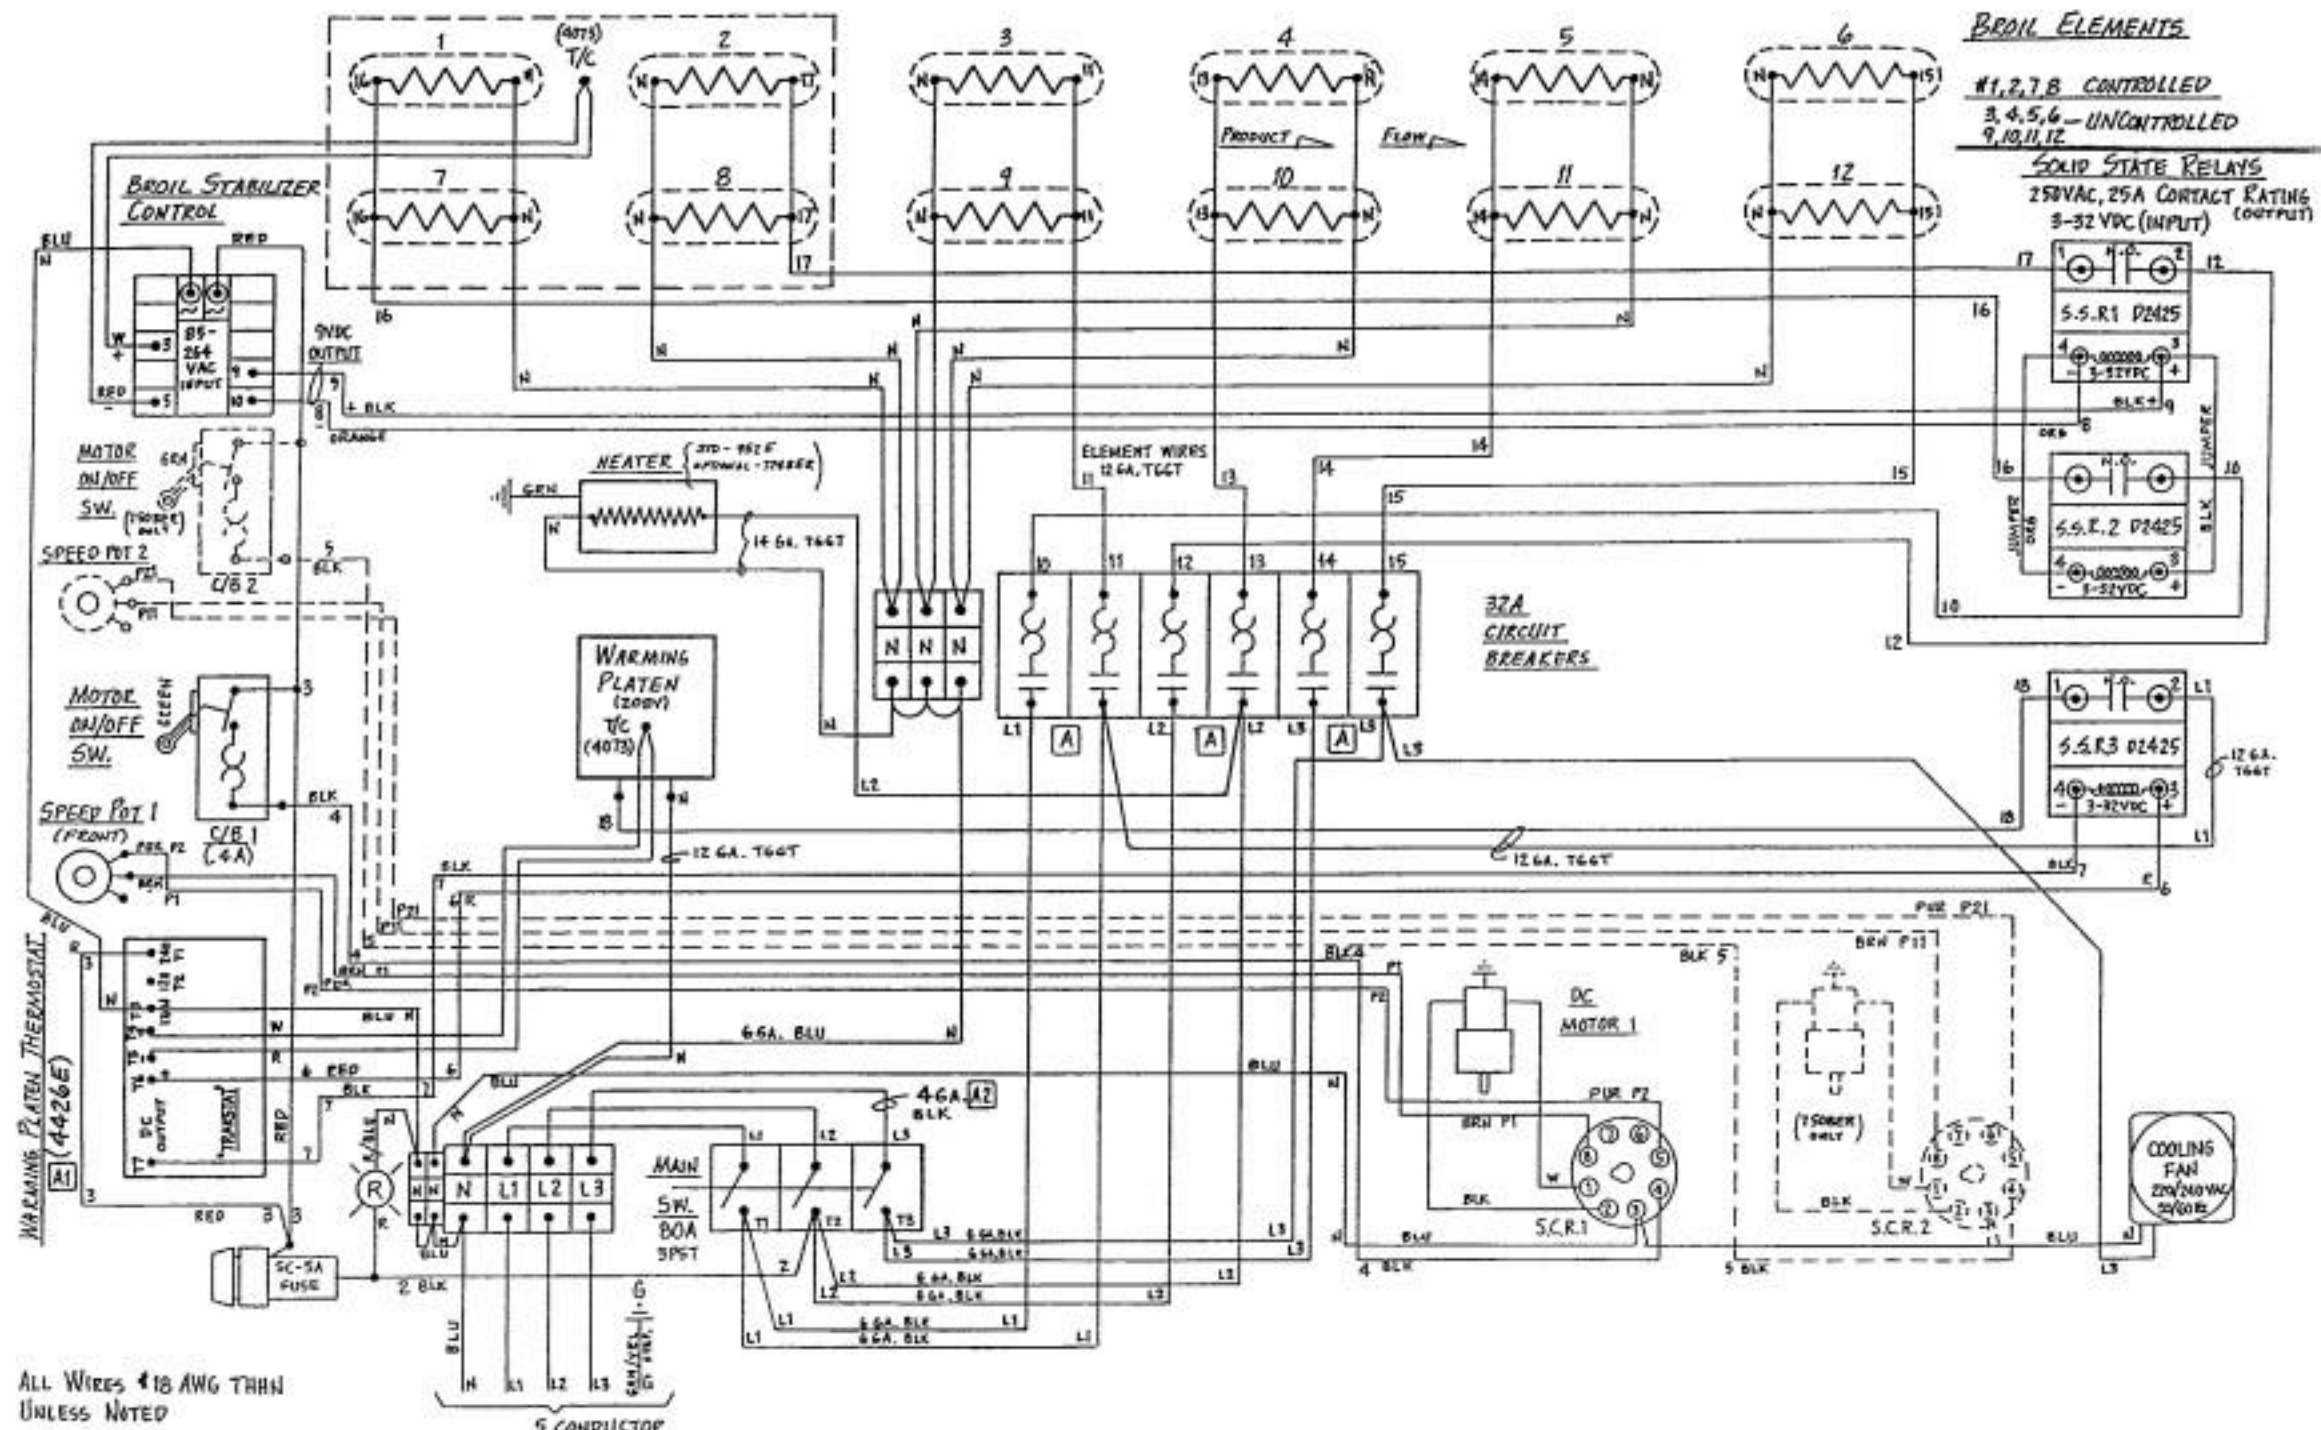
A NEW PLATEN THERMOSTAT, DELETE C/B JUMPERS, INCREASE WIRE SIZE. WAS (1) P/N 4011-P24RC (2) 6GA. 11-7-95 PZ

A NEW PLATEN THERMOSTAT, DELETE C/D JUMPERS, INCREASE WIRE SIZE. WWS1 1) PH 4471-P244C 2) 6 GA. 11-7-93 P2

17

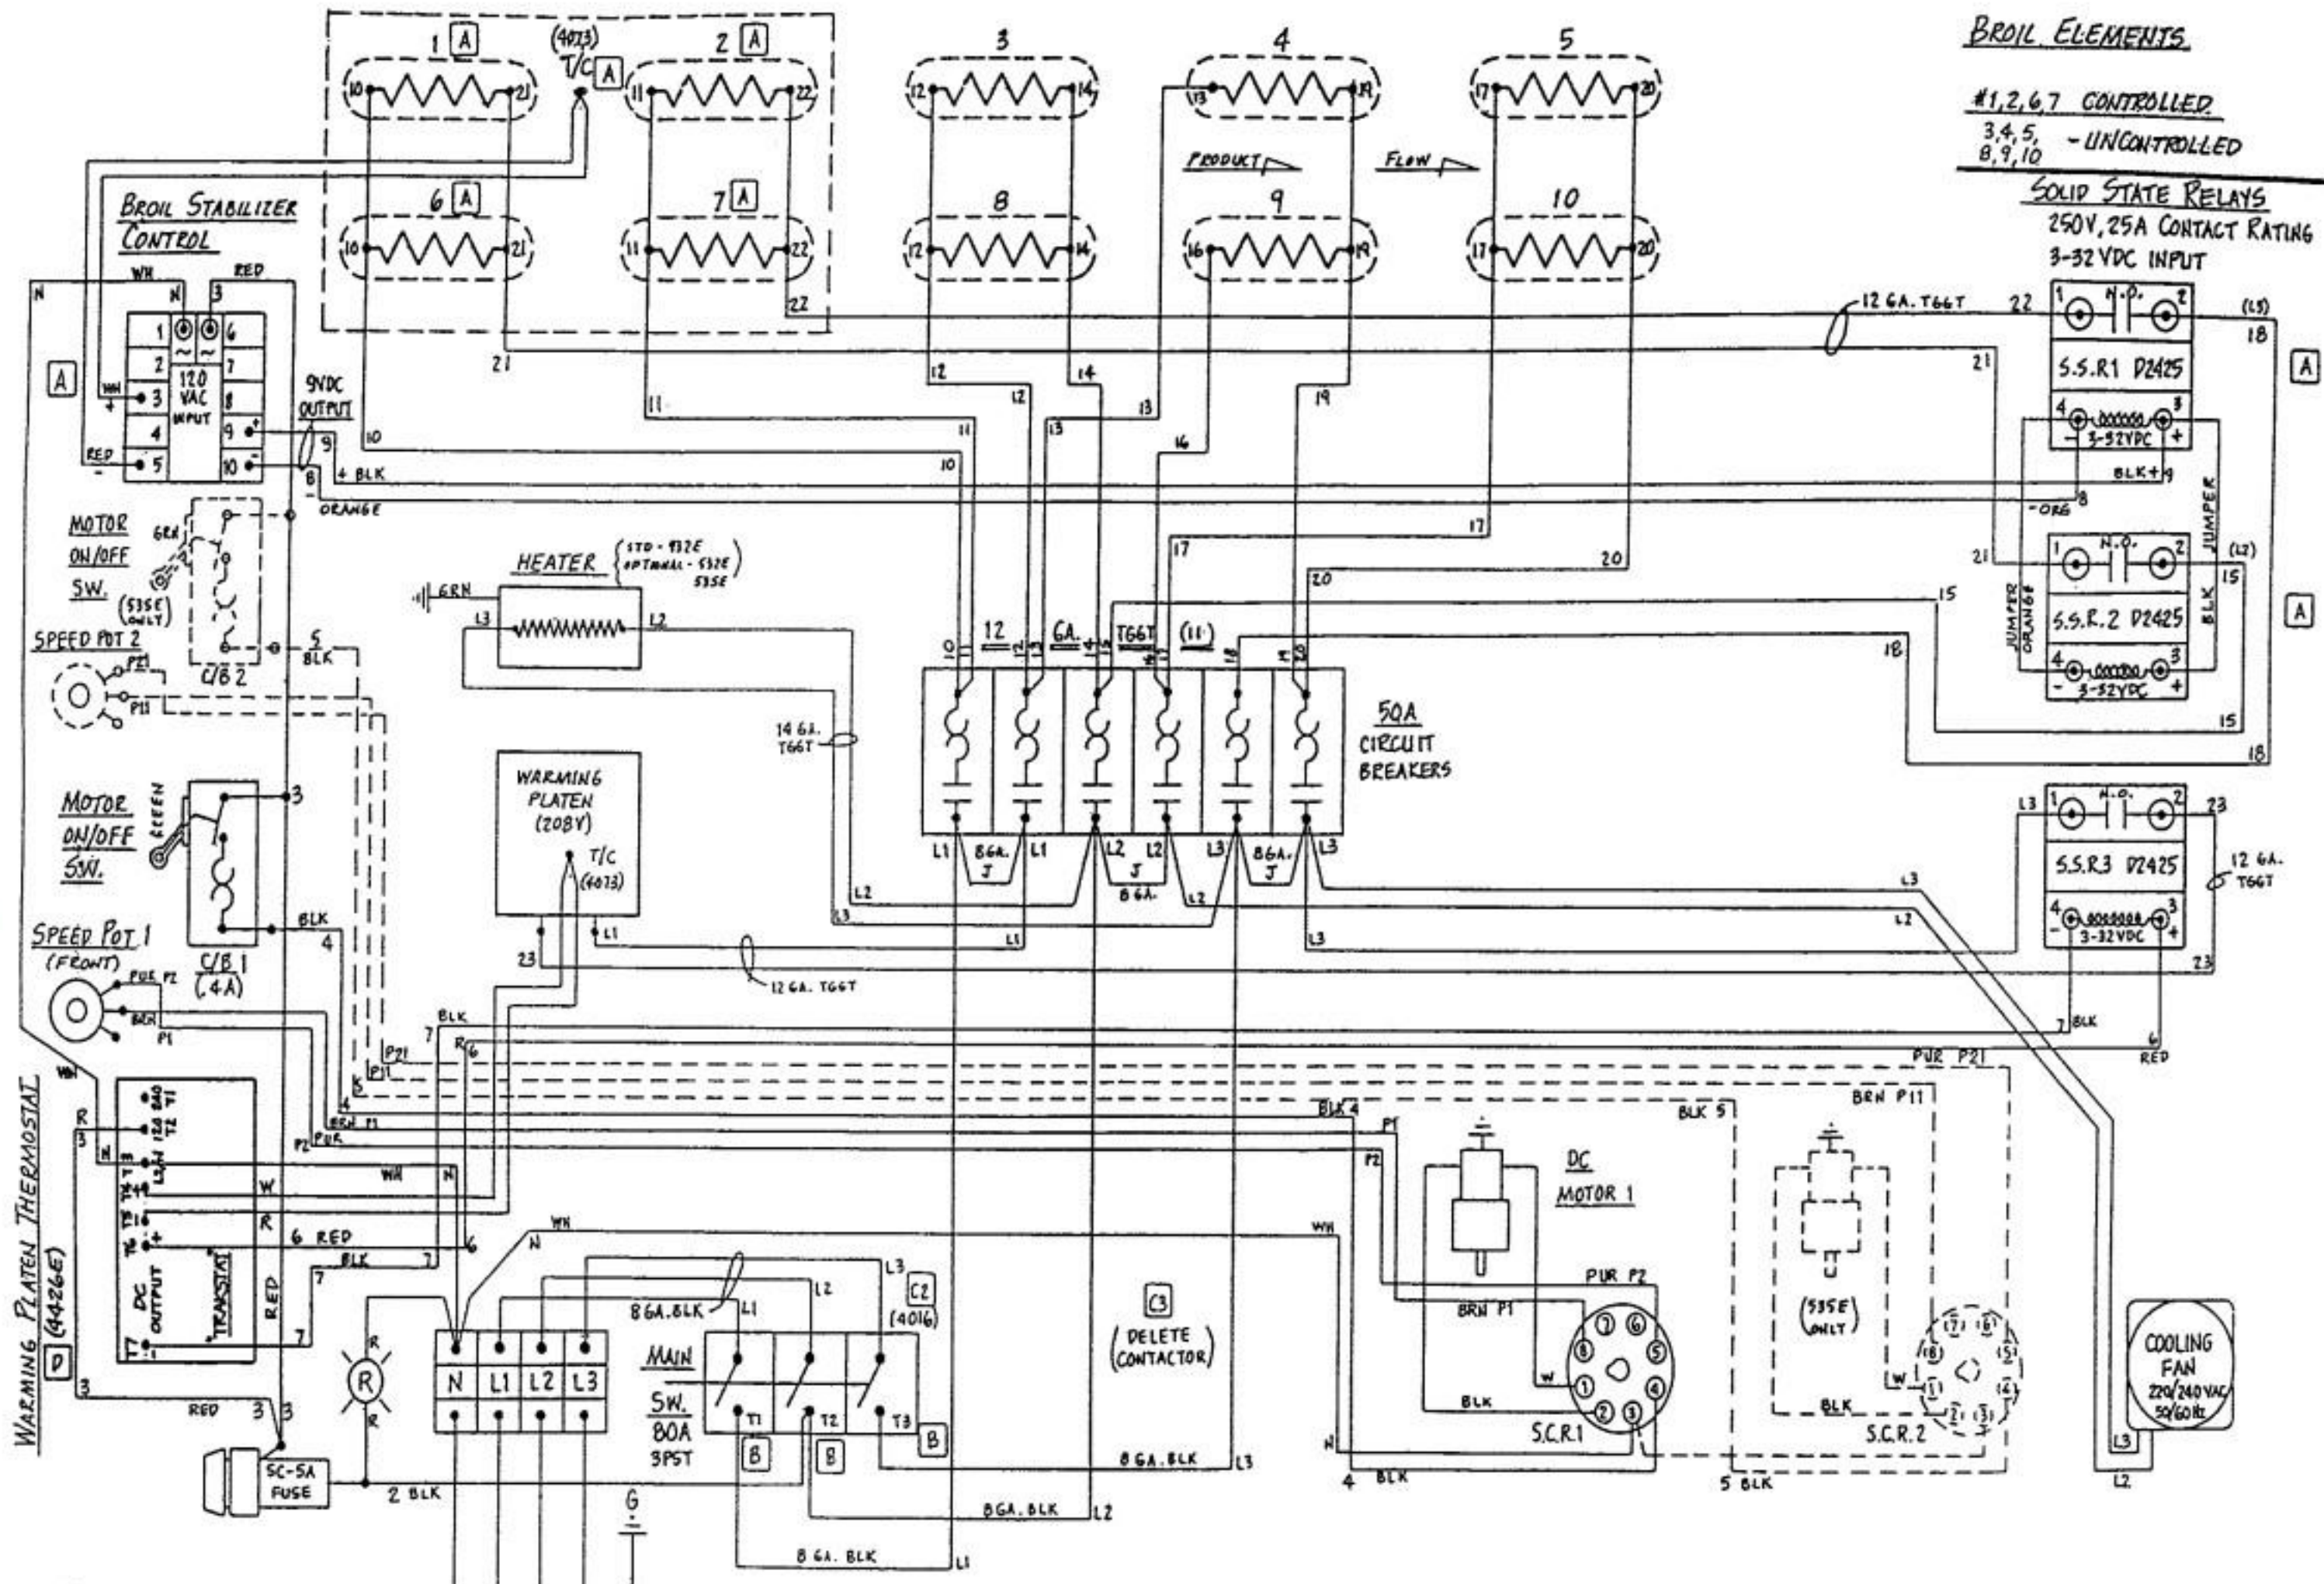
D	NEW PLATEN THERMOSTAT, WAS P/N 4077-2240C	11-7-95	DZ
C	CHANGE PLATEN ATC, MAIN SW., DELETE CONTACTOR, ADD 2ND SCR. WAS: [1] 44073C [2] 4059 [3] 4067	5-10-95	DZ
B	RE-LABEL CONTACTOR FOR U.L.	9-16-94	DZ
A	RE-ORGN. WAS: (6) ELEMENTS, (1) ATC, (1) SSR, (1) T/C	7-14-93	DZ

18

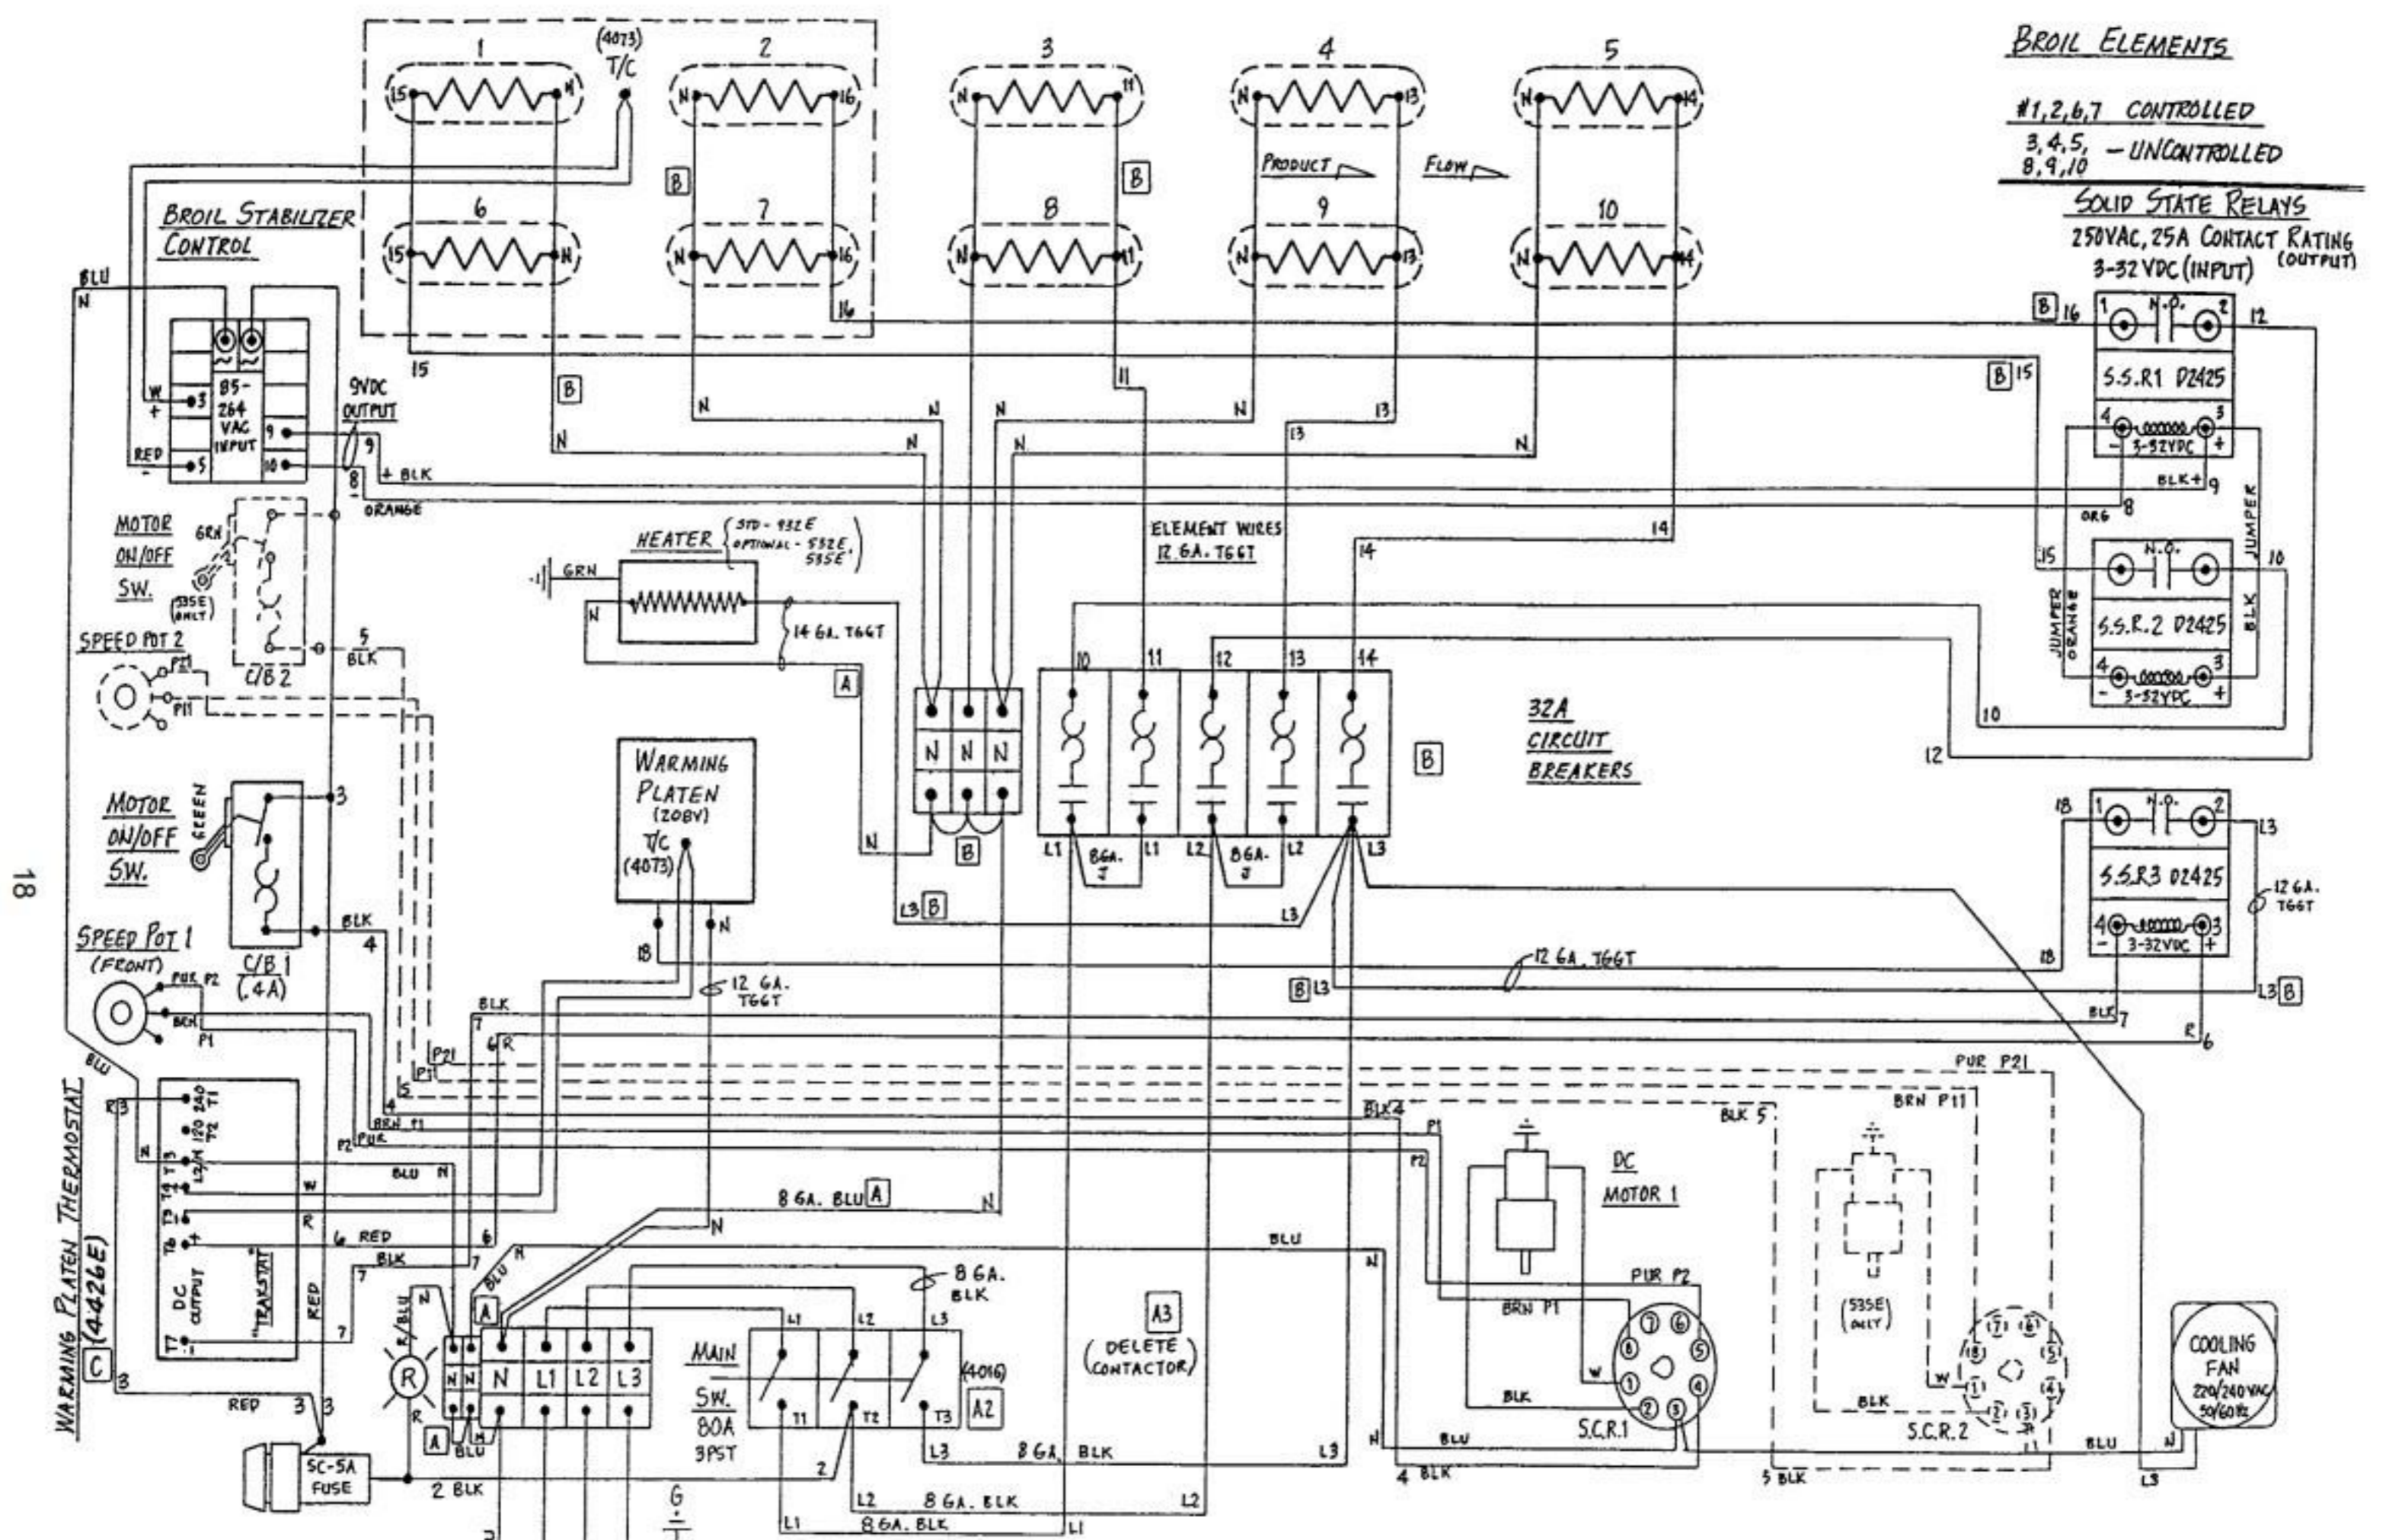
C	NEW PLATEN THERMOSTAT. WAS 4071-P24DC	11-7-95	DZ
B	OMIT (1) C/B, ADD (1) "N" BLOCK	6-20-95	DZ
MODIFY "NEUTRAL" CIRCUITS FOR C.E APP'L, CHANGE MAIN SW., DELETE CONTACTOR			
A	WAS: [1] 4403-DC [2] 4-059 [3] 4067	5-10-95	DZ
